**WARRANTY
BULLETIN**

Wb99-28

DATE : OCTOBER 1999	SECTION : 23 - Accessories
EXPIRATION: OCTOBER 2000	
SUBJECT : REPLACEMENT OF LAVATORY NIGHT LAMP LIGHT BULB

FIGURE 1 : NIGHT LAMP

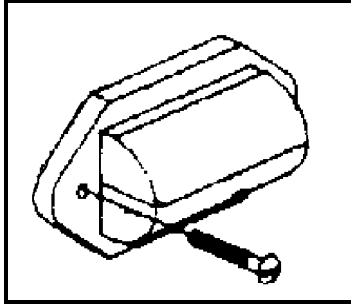
For the above-mentioned vehicles, replacing the lavatory night lamp light bulb with a long lasting light bulb increases the light bulb lifetime expectancy to 15000 hours.

1. Locate the night lamp. The night lamp is the lamp that remains constantly lit when the engine is running. It is located near the lavatory door frame.
2. Unscrew the lamp and remove the light bulb by pulling it from the socket (figure 1).
3. Insert the new light bulb in the socket.
4. Reinstall the night lamp.

Part No.	Description	Qty
562276	Light bulb 657, 28 volts	1
